**TOWN OF NEWBURGH  
PLANNING BOARD  
TECHNICAL REVIEW COMMENTS**

**PROJECT NAME:** MKJC REALTY, LLC  
**PROJECT NO.:** 2023-11  
**PROJECT LOCATION:** SECTION 35, BLOCK 3, LOT 3.22/ NYS ROUTE 32  
**REVIEW DATE:** 15 DECEMBER 2023  
**MEETING DATE:** 21 DECEMBER 2023  
**PROJECT REPRESENTATIVE:** LANC & TULLY ENGINEERS

Re: Site Plan for MKJC Realty LLC  
SBL: 35-3-3.22  
Planning Board # 2023-11

**PROPERTY TREE SUMMARY AND REMOVAL CHART:**

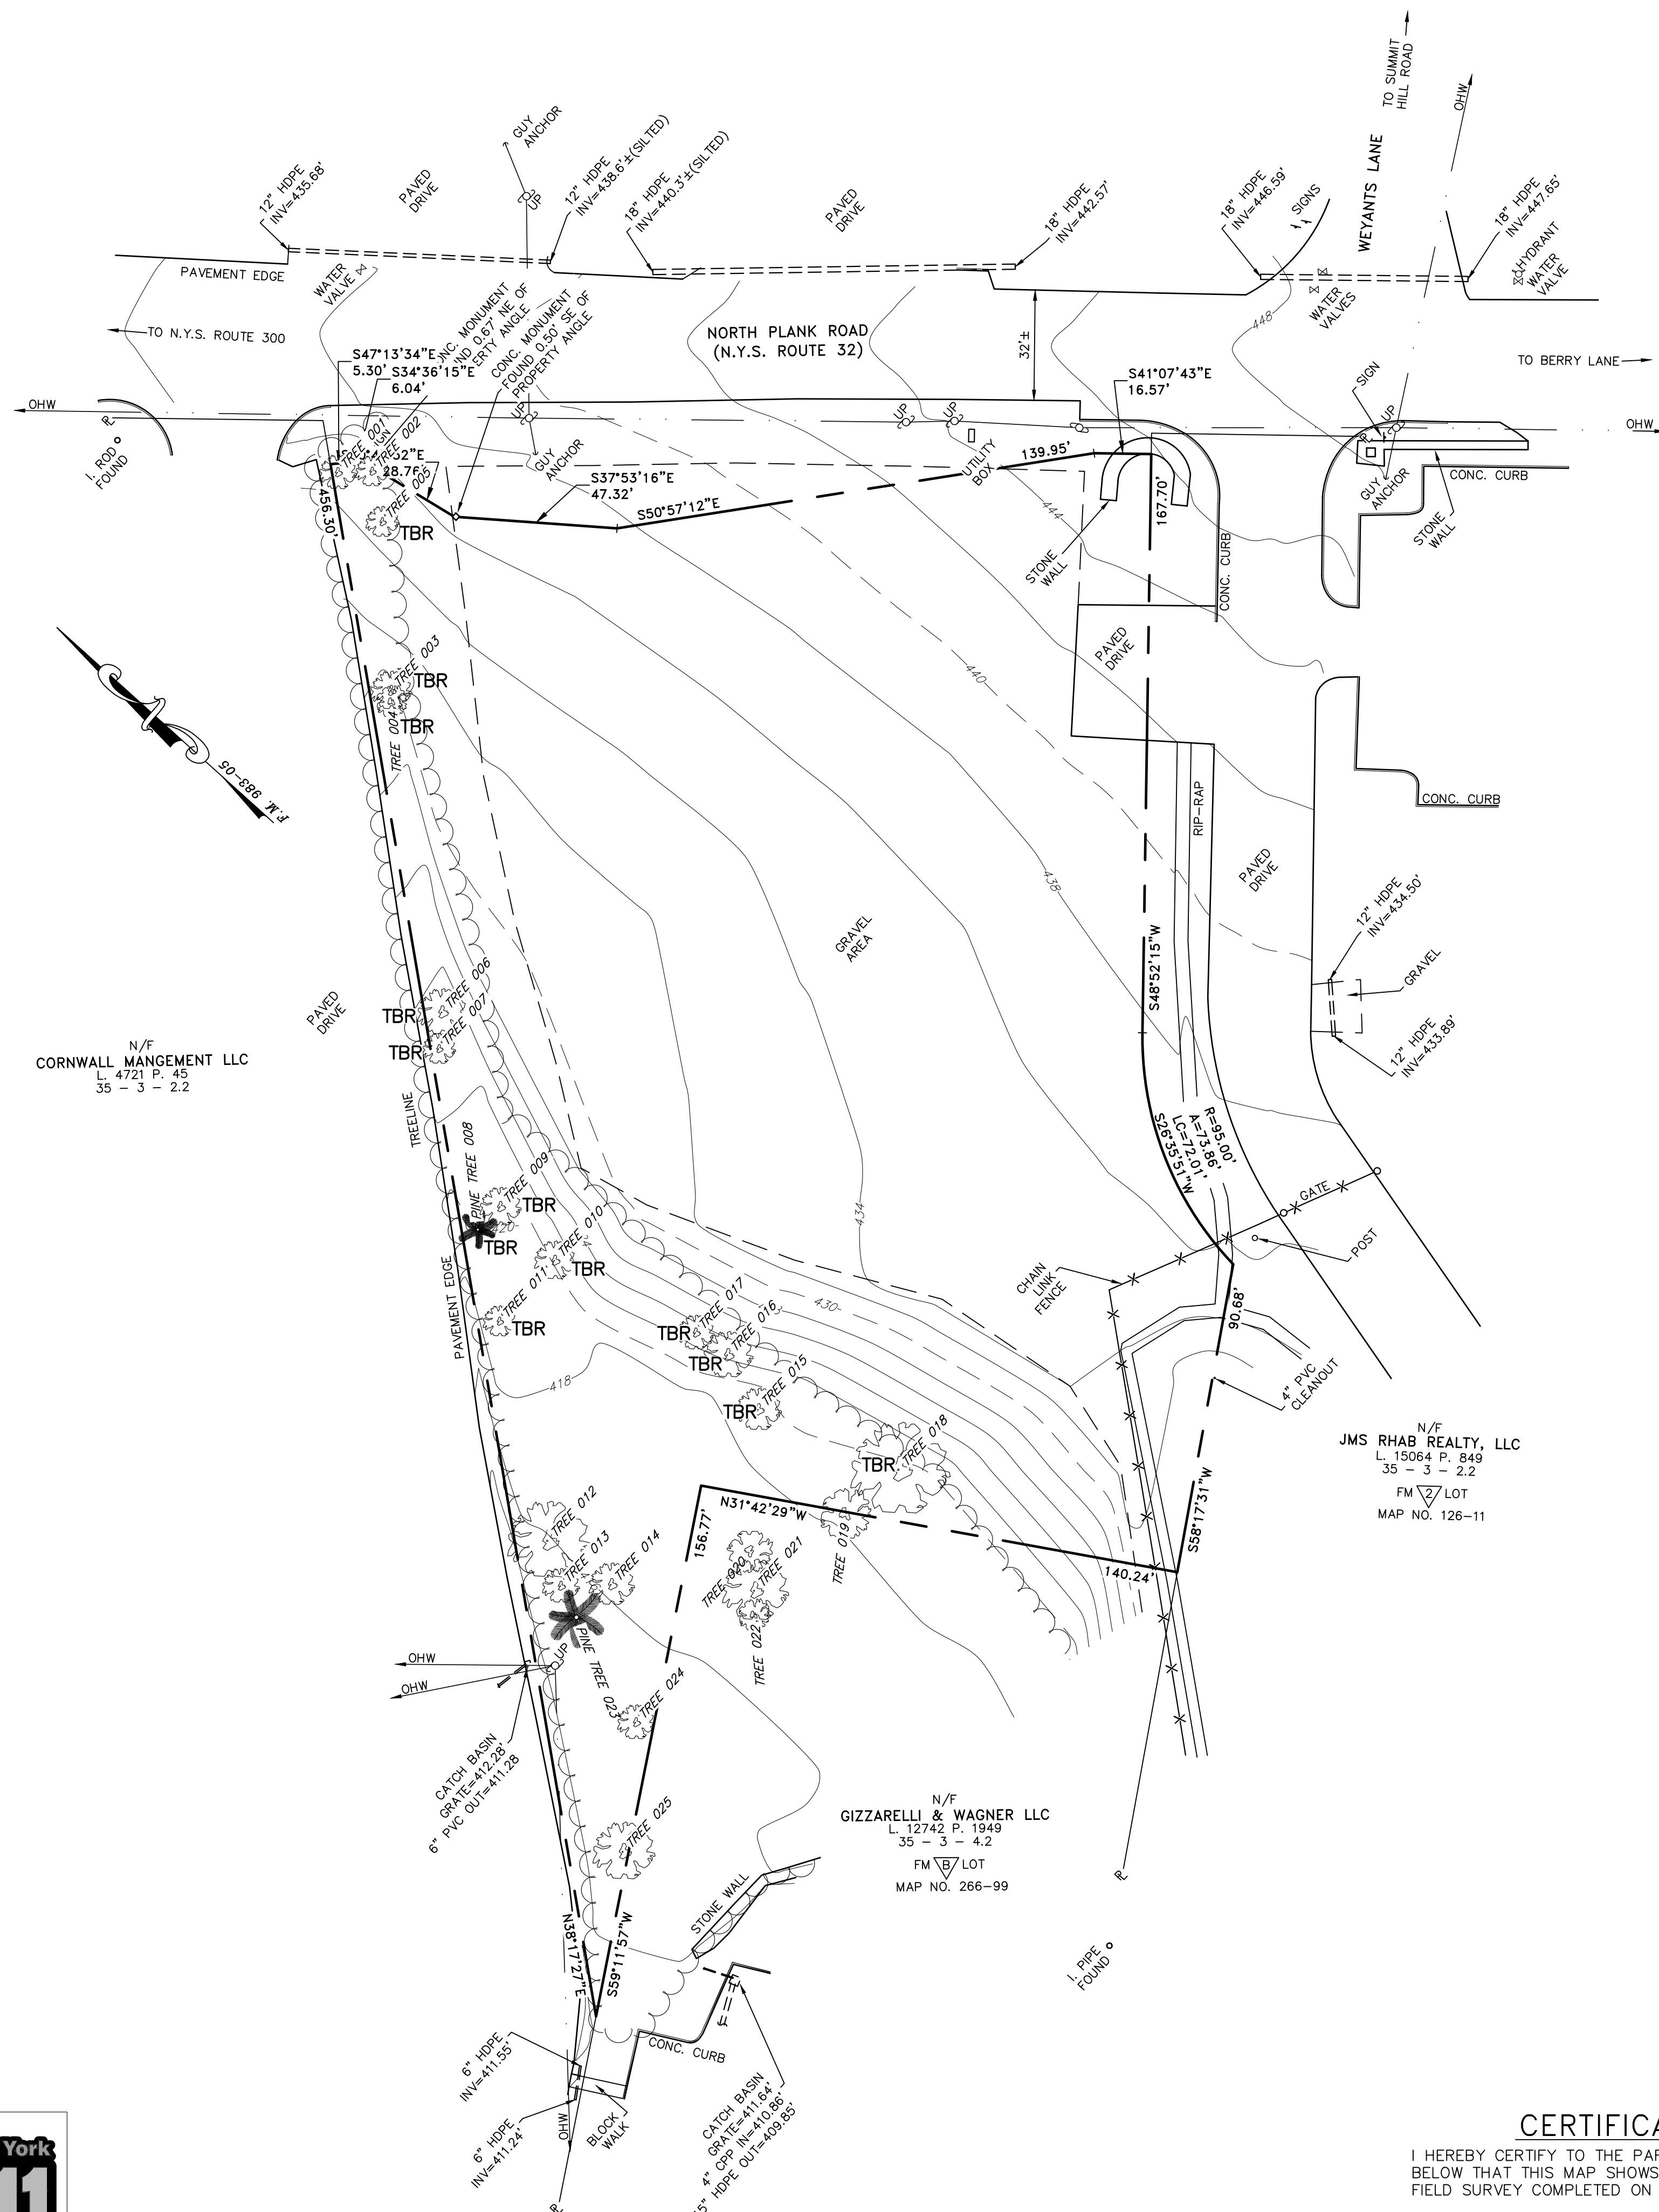
1. The Tree Removal Plan should be modified to identify each of the three classes of trees in the Town Tree Preservation Code. It appears that only a limited number of the trees on the site would be considered under the Tree Code based on diameter.

**RESPONSE: The tree removal chart on sheet 3 of the plan has been updated.**

CD File: ENGDWG  
 Layout: SDS  
 Sheet No.: 5 OF 12  
 Drawing No.: C3D  
 B- 23 - 0107 - 01

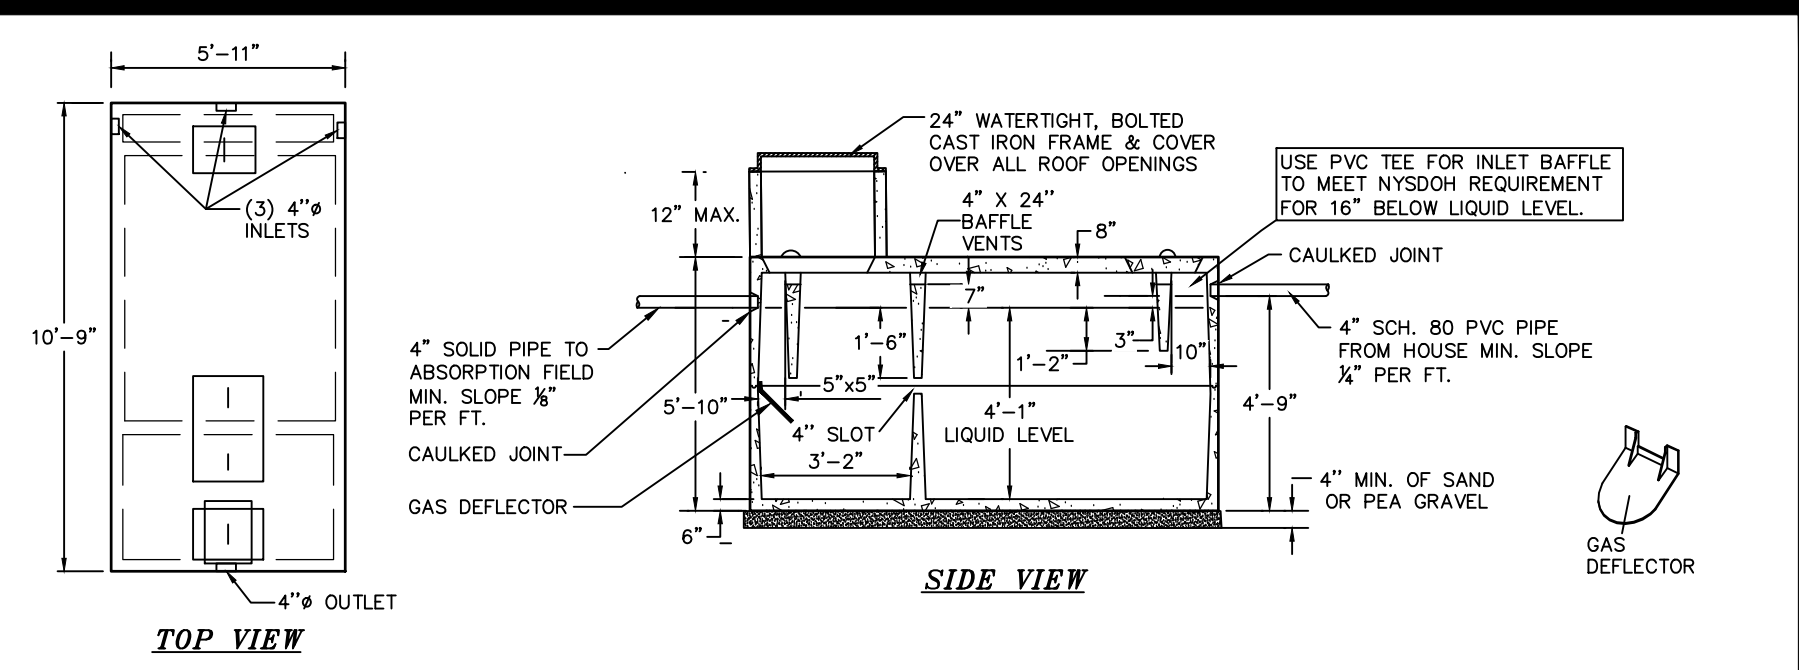
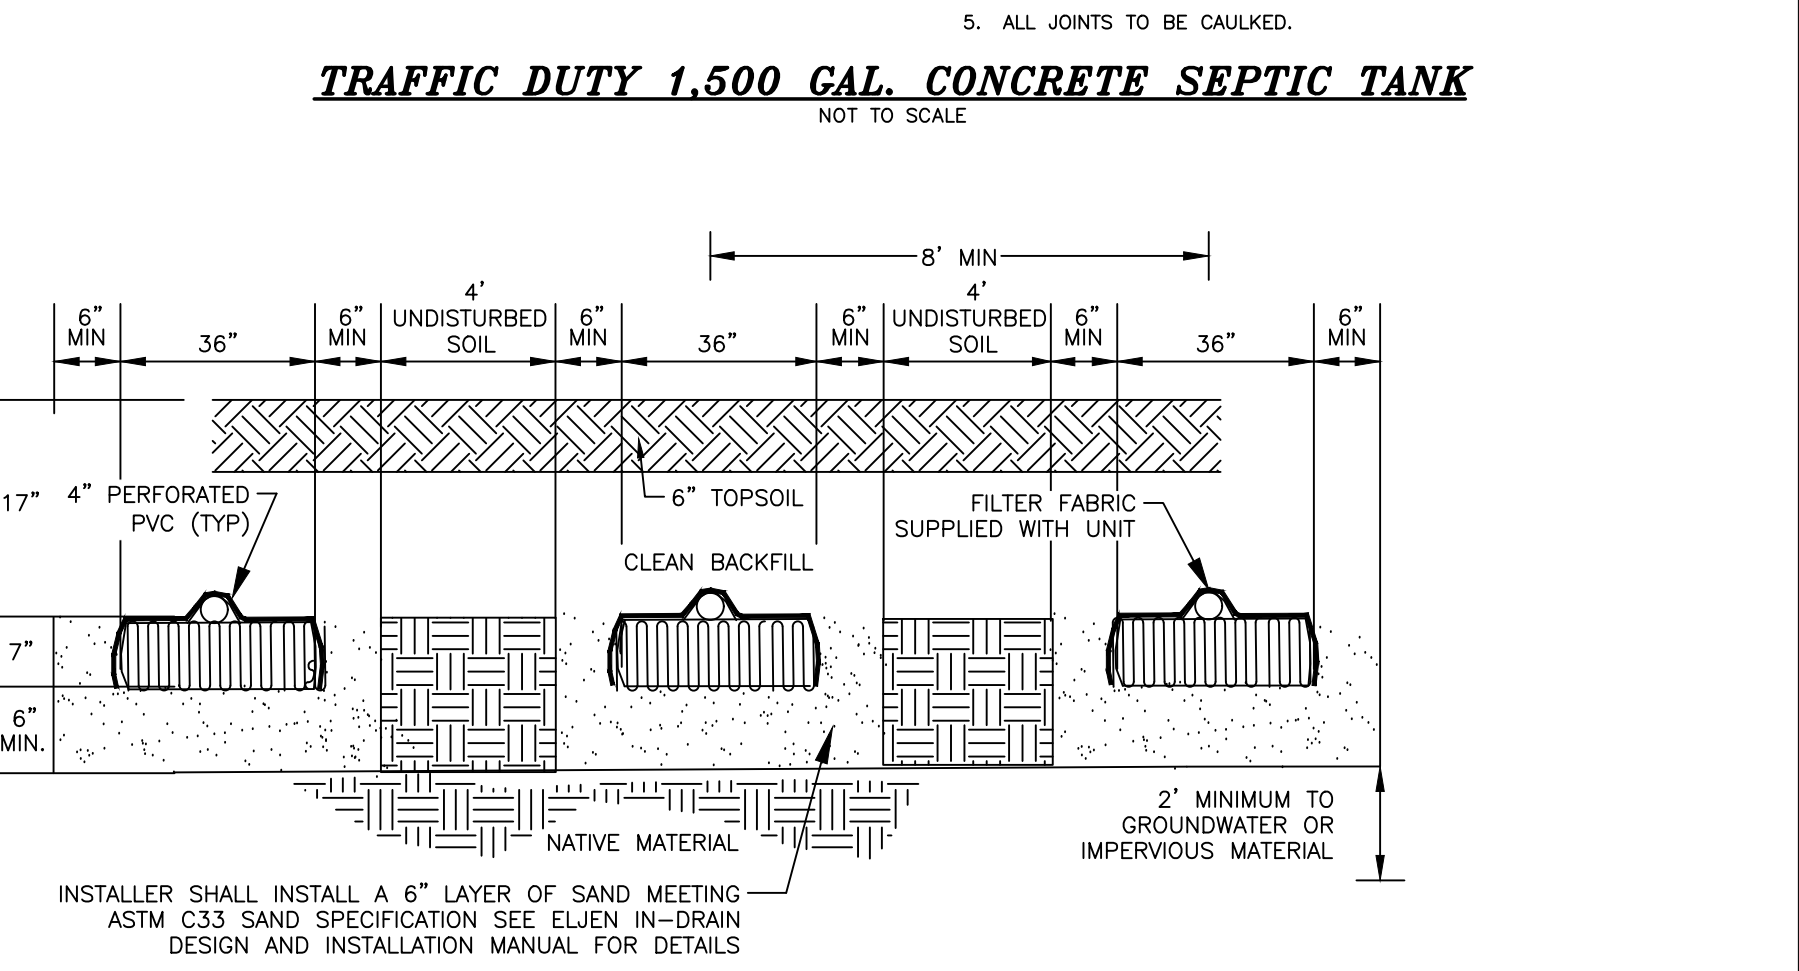
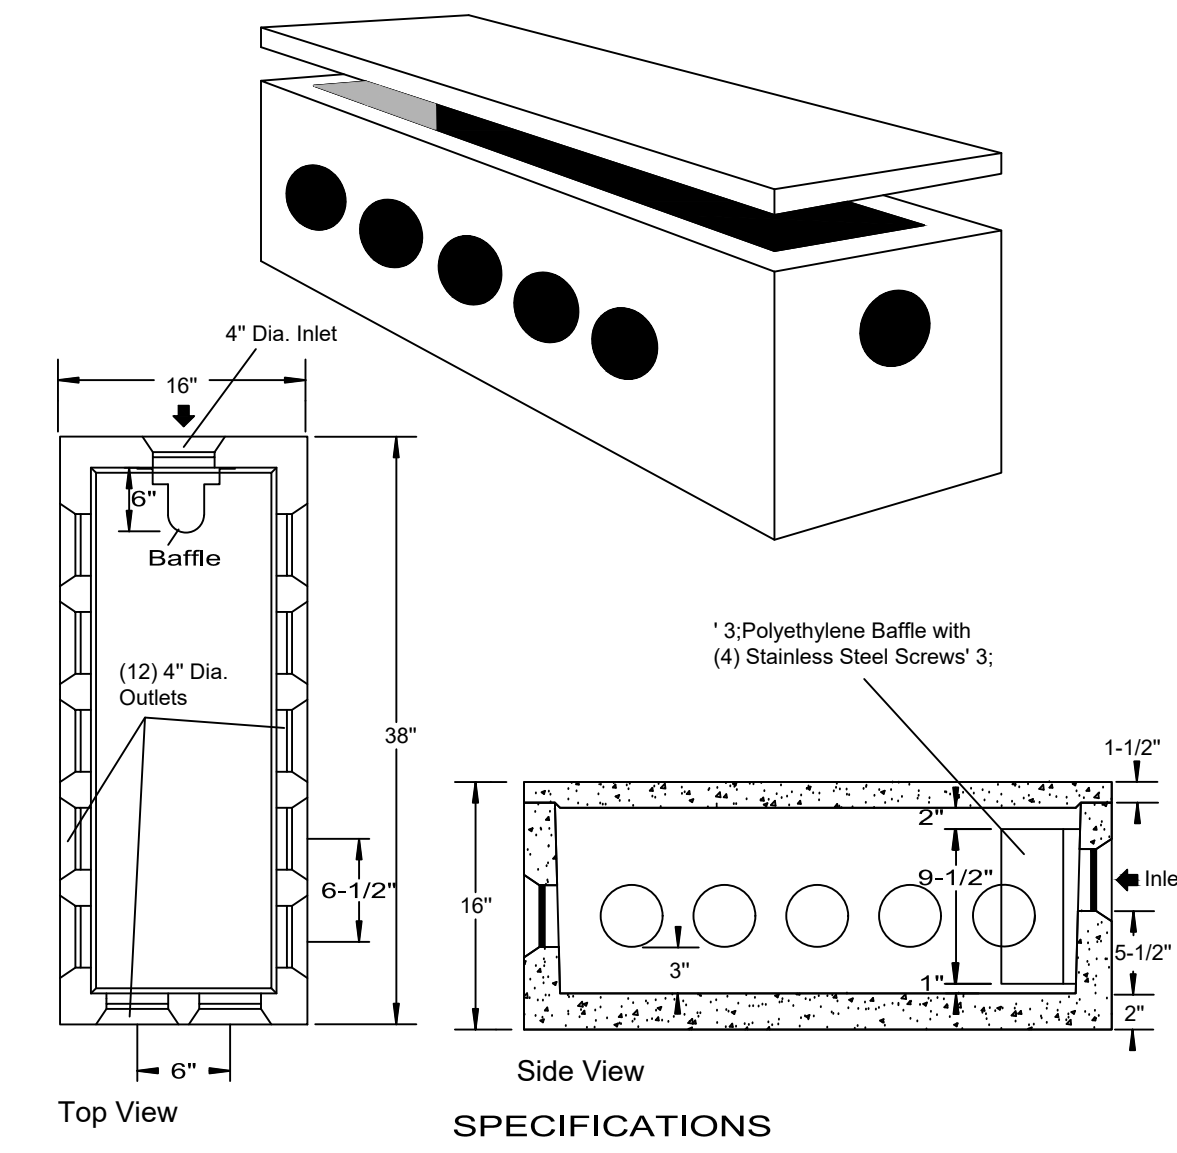
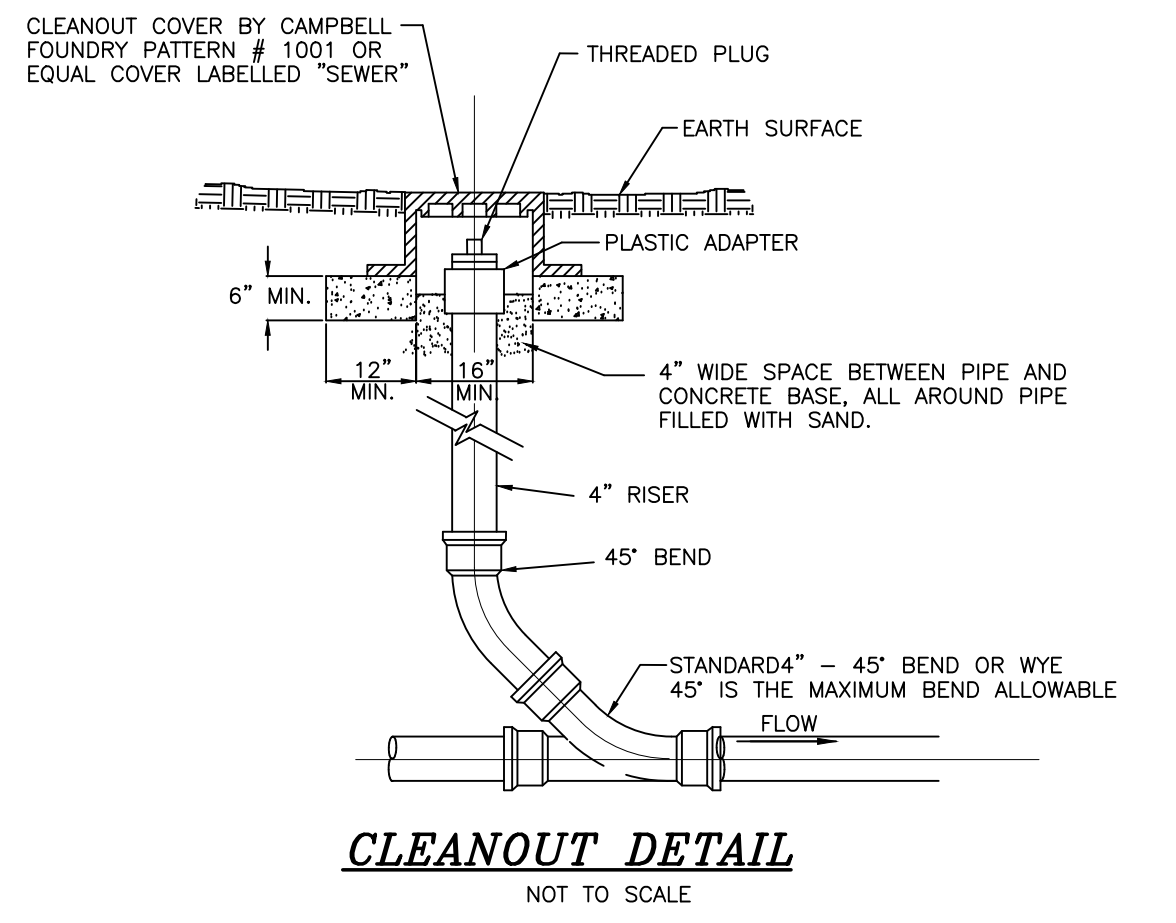
2. Percolation testing for the subsurface sanitary sewer disposal system design is required.

3. The septic design references a PRESBY System, while the details identify an Elgin Proprietary System. This should be clarified.

**RESPONSE: Percolation testing results have been added to Sheet 5 of the site plan.**

**RESPONSE: The reference to PRESBY has been removed and replaced with Elgin on Sheet 5 of the plan set.**

**LANDSCAPING DRY-SET STONE RETAINING WALL DETAIL**  
NOT TO SCALE

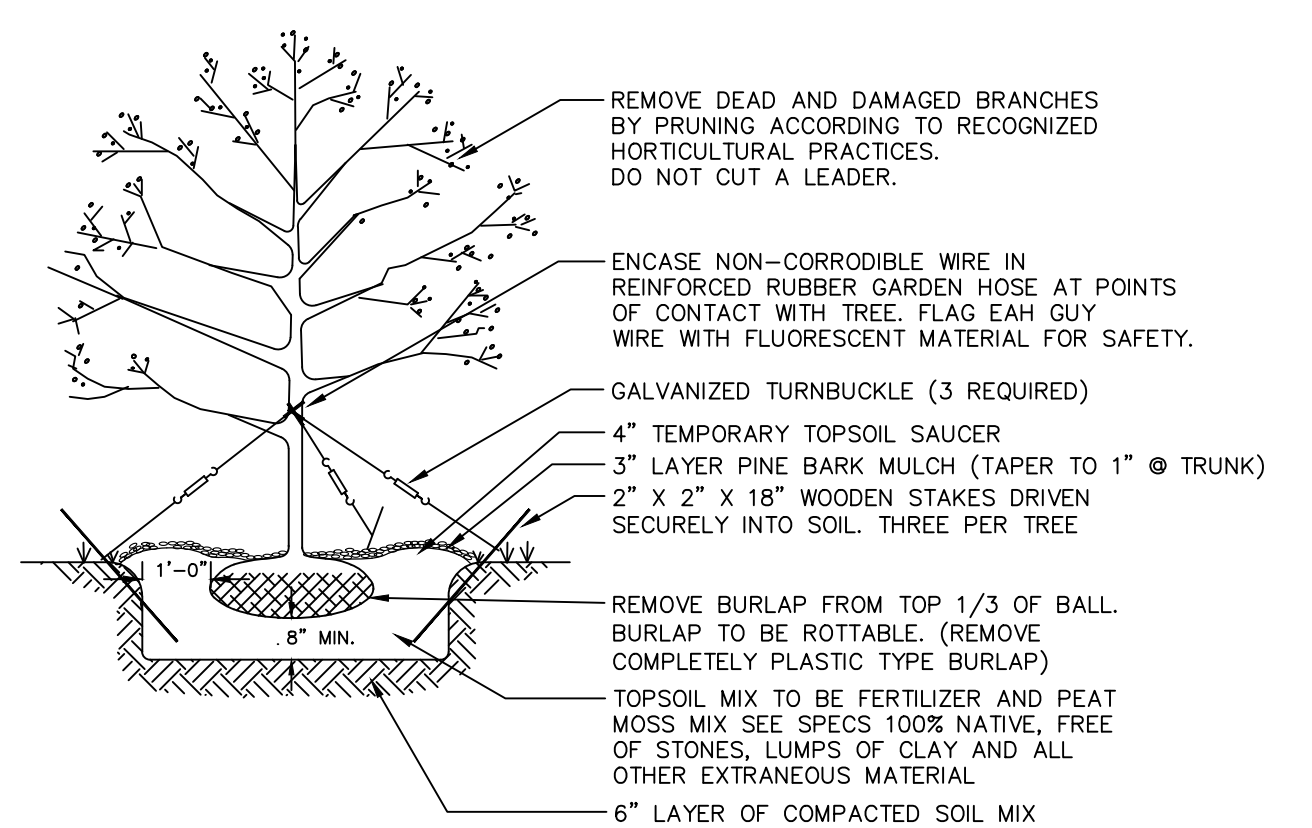
7. The applicants are proposing a dry-laid stone wall along the entire property frontage to mitigate the parking in front of the structure which is inconsistent with the Town's Design Guidelines. The height of the stone wall is identified as varies in the detail. The height of the wall should be identified in the detail.

**RESPONSE: The detail on Sheet 8 has been revised to indicate the height of the wall is 30".**

**OUTLET PROTECTION DETAIL FOR RETAINING WALL PIPE PENETRATION**

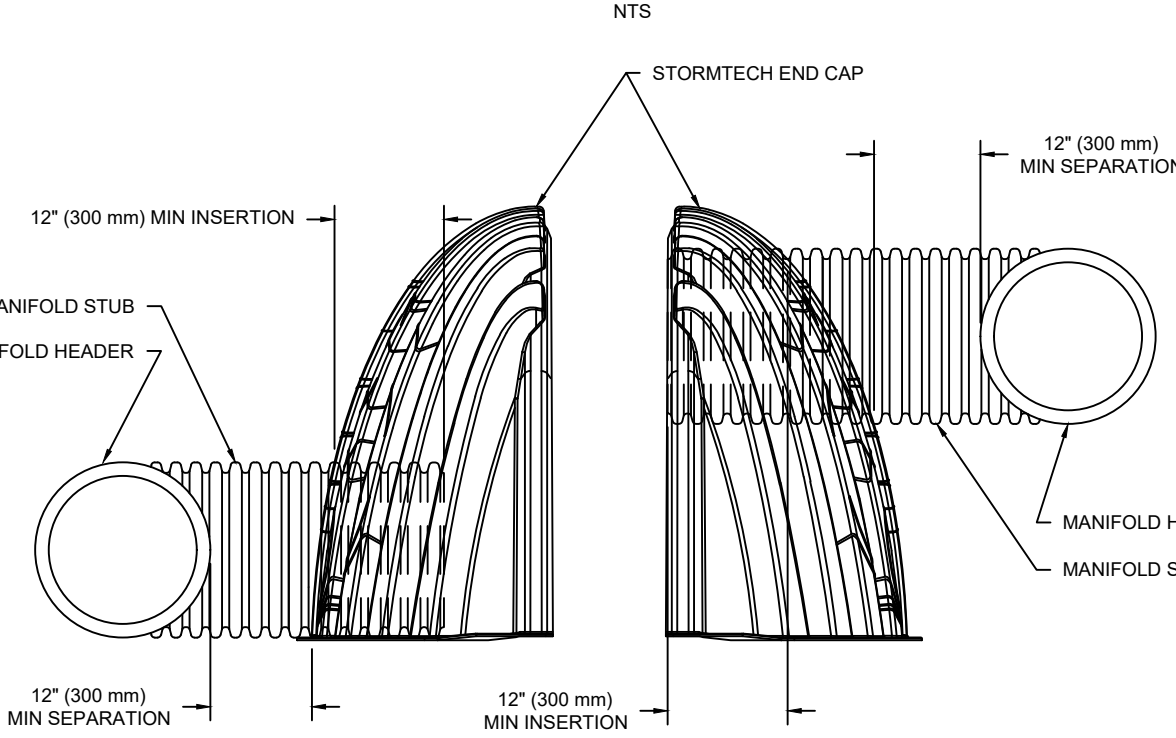
9. The outlet protection for retaining wall pipe penetration detail did not print on Plan Sheet 12 of 12.

**RESPONSE: The detail has now been depicted on the plan Sheet 12.**
